REVIEWER 1

The paper discusses the key issues of the Earthquake Risk Model of Switzerland (ERM-CH23). It is the result of huge work from the hazard, vulnerability and exposure sides. Authors summarize the main input and output of the study, including the comparison with other models. Such large research effort typically goes in research reports because a journal paper is often too short and also these projects implement state of the art research without actual scientific innovation. This is also the case of this manuscript in my opinion. Reproducibility is also impossible based on this work. Therefore I regret that I cannot recommend this manuscript for publication until it qualifies as a research paper. This notwithstanding, I appreciate the work and understand many of the authors are directly involved in the special issue this manuscript is submitted to. I also offer some comments as listed.

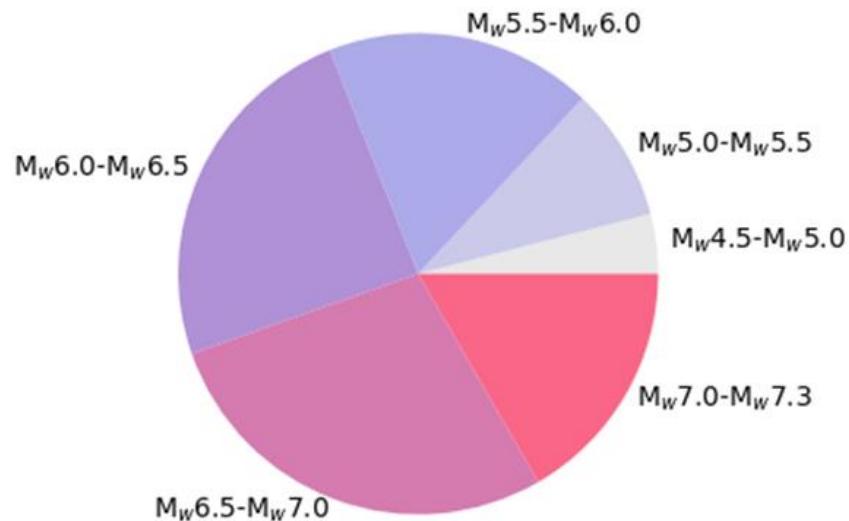
b. An analysis of small damaging earthquakes is provided by Nievas et al. (2020). Therein (Fig 13), the authors estimate the proportion of damaging M4.00-M4.25 earthquakes at ~0.2% and of damaging M4.25-M4.50 earthquakes at ~1%. Now these are global statistics and arguably subject to many uncertainties and likely ascertainment bias. But let's take them as a ballpark estimate for the sake of this

argument, and also assume a Gutenberg-Richter magnitude frequency distribution with a b-value of 1.0:

With the b=1 assumption, for every 200 earthquakes with $M>4.25$, 112 of them will, on average, be in the 4.25-4.50 range. If we assume that 1% of the $M4.25$ - $M4.50$ earthquakes will be damaging, that means that we will have about 1 of those small earthquakes cause some damage. This damage (as intuitively expected, and also informed by sensitivity checks carried out as part of ERM-CH23) is going to be minimal and several orders of magnitude smaller than the damage caused by $M>6$. For reference, under the same b=1 assumption, around ~3-4 of the 200 earthquakes would be expected to be $>M6$, and all of them would cause significant loss.

Therefore, the contribution of such small and rarely damaging earthquakes is expected to be minimal (see also following point).
